Sub Regional RTEP Committee PJM South

June 17, 2019

Scope Change / Cost Increase

Existing b2626 Scope and Cost Modification

Dominion Transmission Zone: Baseline Line #34 and Line #61 (Partial) Skiffes to Yorktown Rebuild

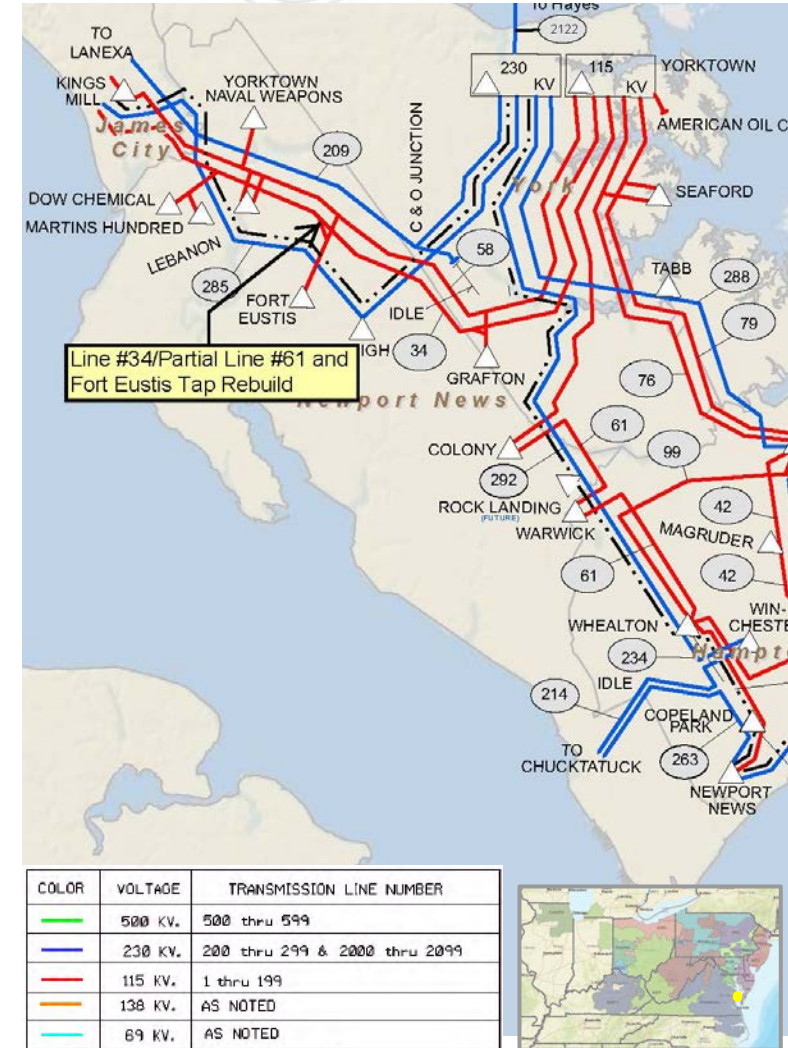
Original: Baseline Project: Line #34 and Line #61 (Partial) Skiffes to Yorktown Rebuild

Revised: Line #34 and Line #61 (Partial) Skiffes to Yorktown Rebuild and Fort Eustis Tap Rebuild

- The 13 mile 115kV line #34 from Skiffes Creek – Yorktown was built on wood H-frames in the 1940's and 1950's. The first 4.5 miles out of Yorktown is on 3 pole double circuit wood H-frames with the line #61. The line #34 and the double circuit portion of the line #61 have been identified for rebuild based on the company's End of Life criteria.

Additional Driver:

- Fort Eustis is served from a 2.5 mile radial line tapped off of line #34. The first 1.6 miles from the tap point is of similar vintage as parts of the main line #34. The remaining 0.9 miles of the tap line was built on wood poles in late 1960s. This tap line is at or approaching it's end of life and has been identified for rebuild.

Revised Proposed Solution

- (Same as original solution)** Rebuild the main line #34 and the double circuit portion of the line #61 to current standards. **(Est. cost \$24M)**
- Based on the company's FIR requirement for a tap line longer than 1 mile, rebuild the 2.5 mile tap line to Fort Eustis as Double Circuit line to loop line #34 in and out of Fort Eustis station to current standard with a summer emergency rating of 393 MVA at 115kV. Install a 115kV breaker in line #34 at Fort Eustis station.

(Est. cost \$11.7M)

Dominion Transmission Zone: Baseline Line #34 and Line #61 (Partial) Skiffes to Yorktown Rebuild

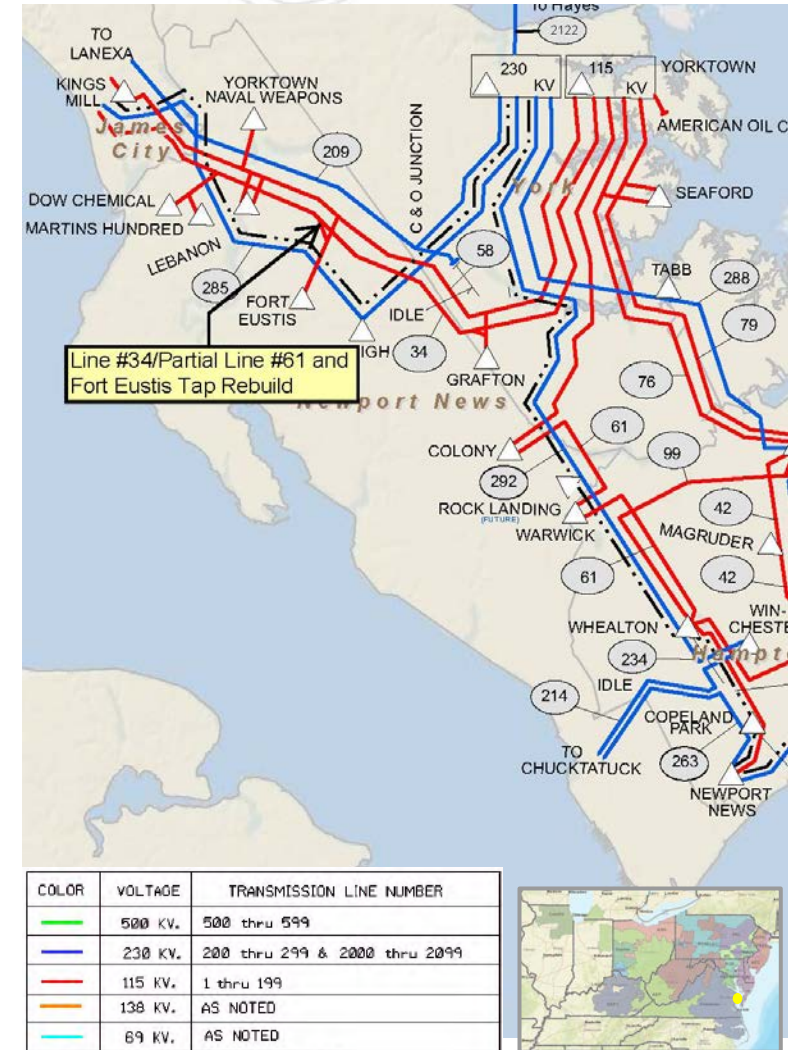
Revised: Line #34 and Line #61 (Partial) Skiffes to Yorktown Rebuild and Fort Eustis Tap Rebuild

Alternatives

- **(Same as original solution)** Rebuild the main line #34 and the double circuit portion of the line #61 to current standards. **(Est. cost \$24M)**
- Based on the company's FIR requirement for a tap line longer than 1 mile, build a 3-breaker ring bus station in line #34 at Fort Eustis tap point. Rebuild the 2.5 mile tap line to Fort Eustis as Single Circuit line to current standards with a summer emergency rating of 393 MVA at 115kV. **(Est. cost \$16.4M)**

Dominion Transmission Zone: Baseline 115kV Line #29 Fredericksburg to Aquia Harbor End of Life

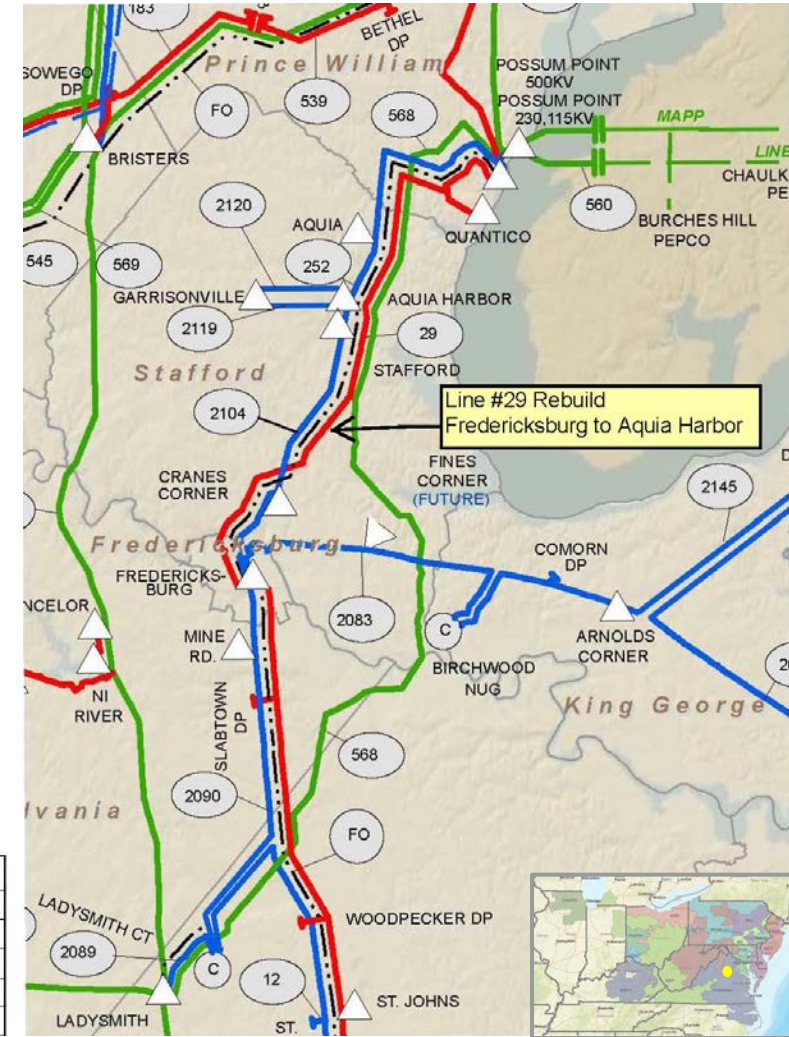
Existing b2981 Cost Increase

- Total line length of 115kV Line #29 is 24.4 miles and runs between Fredericksburg Substation and Possum Point Power Station. The proposed rebuild segment of the 115kV Line #29 between Fredericksburg and Aquia Harbor is approximately 12 miles long and was constructed on wood H-frame structures in 1957. Existing conductor in the proposed rebuild segment is a combination of 1109 ACAR, 2-721 ACAR and 795 ACSR with a summer rating of 239 MVA. The remaining 12 miles of Line #29 is on a common 230kV lattice structure with Line #252 (with the exception of the tap to Quantico) with a summer conductor rating of 361 MVA at 115kV.

- This line provides service to Quantico Substation with a total of 440 customers including the Quantico USMC Base. Quantico Substation is connected to Line #29 with a 1.7 mile 115kV tap off the main line.

- Rebuilding this 12 mile segment of Line #29 to current 230kV standards (with continued operation at 115kV) would be consistent with the Company’s practice of containing or converting 115kV load in the Northern Virginia area and would support the future conversion of the entire Line #29 to 230kV with the remaining 12 miles already installed on 230kV structures.

Rebuild Line #29 segment between Fredericksburg and Aquia Harbor to current 230kV standards (operating at 115kV) with a normal continuous summer rating of 524 MVA at 115kV (1047 MVA at 230kV). (b2981)

Conceptual Project Cost: \$12.5M

Revised Detailed Project Cost: \$20.0M

Reason for Cost Increase: Detailed versus conceptual cost estimate.
